Draft
04/04/2016

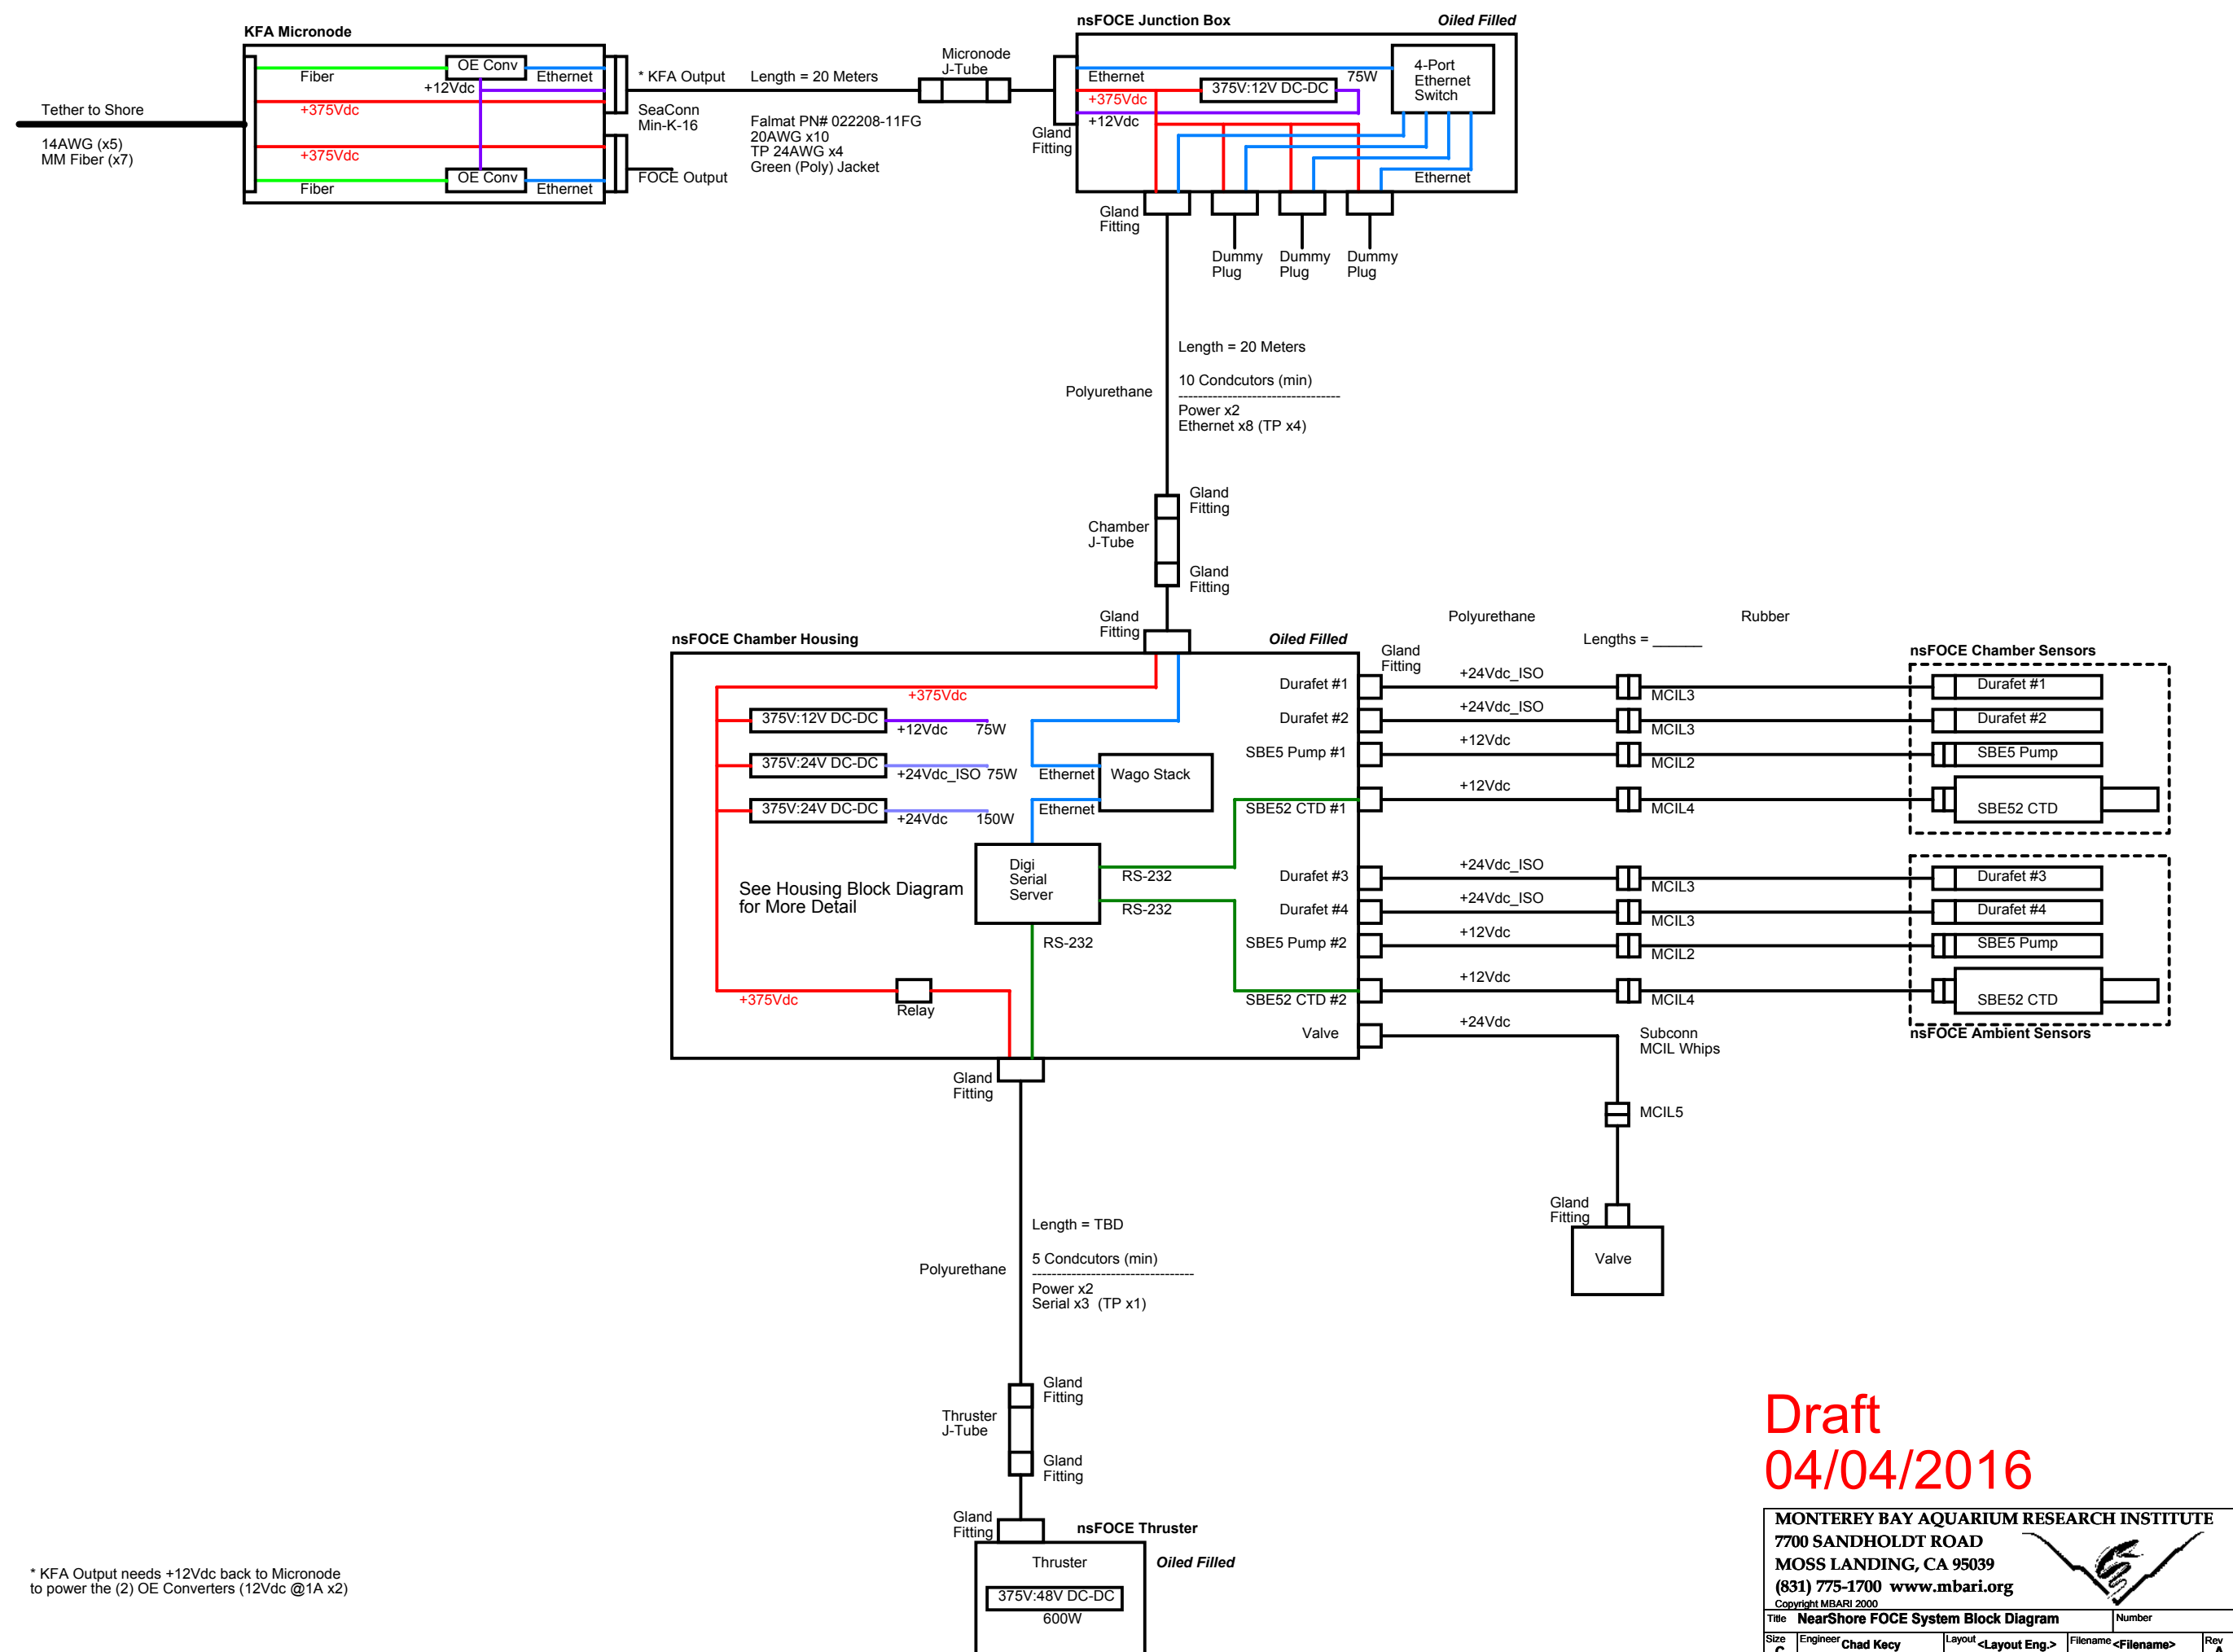
* KFA Output needs +12Vdc back to Micronode to power the (2) OE Converters (12Vdc @1A x2)
